Campaign No. 2001010002

January 2001

TO: ALL MERCEDES-BENZ CENTERS
 SUBJECT: **MODELS 220, 215**
REPLACEMENT OF HEATED WASHER HOSE

Figure 1

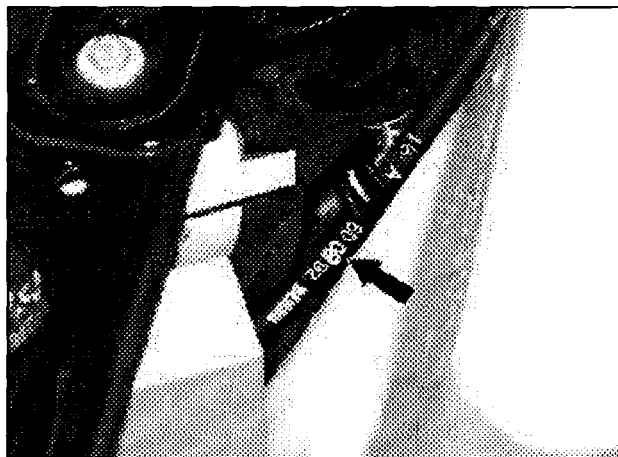
The **faulty** heated washer hose, which is located next to the washer water reservoir behind the right hand headlamp, is identified via both the part number 220 860 08 92 (arrow, Figure 1) **and** a single PVC tube covering both wires (arrow, Figure 2) at the electrical connector.

1. Part number 220 860 **05** 92
- Or
2. Part number 220 860 **08** 92 with **two** separate wire covering tubes per heater wire.

Figure 2

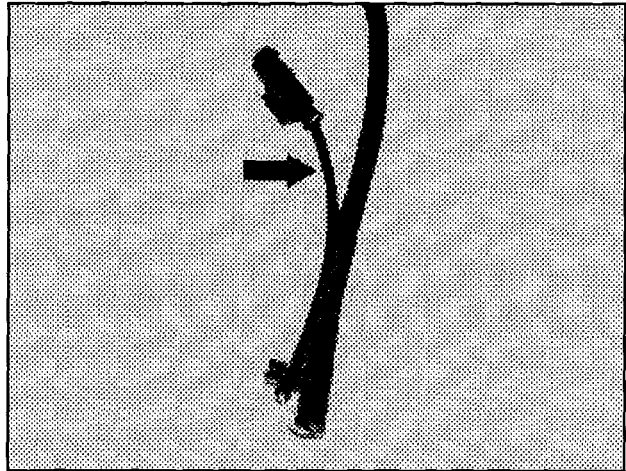
Single PVC tube covering both wires (arrow, Figure 2) at the electrical connector (12, Figure 3) shown.
